**UNITED STATES COURT OF APPEALS
FOR THE DISTRICT OF COLUMBIA CIRCUIT**

No. 24-1288

PETITION FOR REVIEW

National Emission Standards for Hazardous Air Pollutants for Coke Ovens: Pushing, Quenching, and Battery Stacks, and Coke Oven Batteries; Residual Risk and Technology Review, and Periodic Technology Review**AGENCY:** Environmental Protection Agency (EPA).**ACTION:** Final rule.

Commenter’s Figure 1: Plot of door leak data from the EPA’s CAA section 114 request with assumed current and proposed values of PLD_{bench only}.

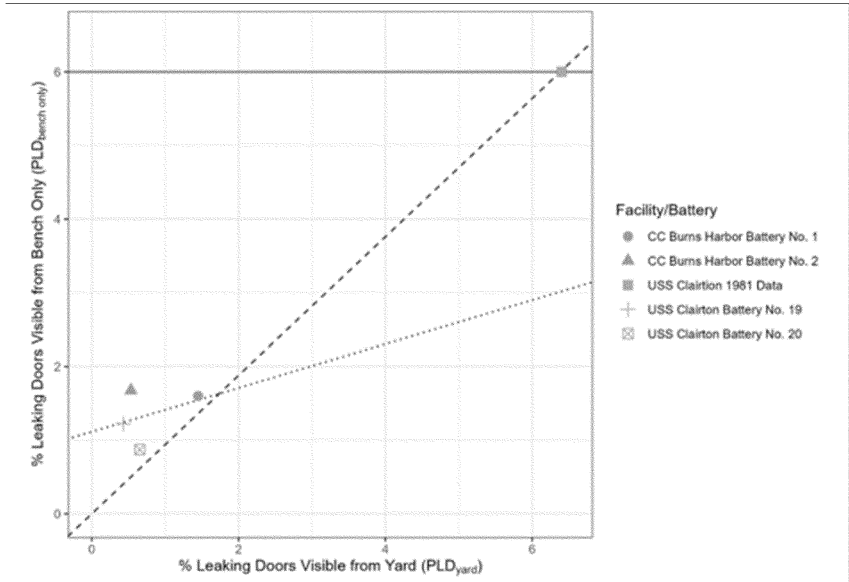
Comment: A commenter stated they believe the EPA’s proposed change to the equation for estimating leaks would underestimate PLD_{bench} and thus COE, and proposed an alternative equation. To test the EPA’s proposed change, the commenter plotted PLD_{bench} versus PLD_{yard} (shown in this section as Commenter’s Figure 1). The commenter asserted that for a valid equation the points should fall along a line with a slope of 0.94 and intercept of 0, and that because data for these four batteries in Commenter’s Figure 1 are above this line, the EPA’s proposed equation underestimates PLD_{bench} and thus COE.

The commenter continued that another issue is that the EPA’s proposed change assumes that PLD_{bench} is zero when PLD_{yard} is zero. However, even when there are no leaks visible from the yard, there will still likely be leaks visible only from the bench. It appears a more appropriate method for estimating PLD_{bench} from PLD_{yard} is to fit a line to the data with a non-zero intercept. Doing so yields the following equation for estimating PLD_{bench} from PLD_{yard} :
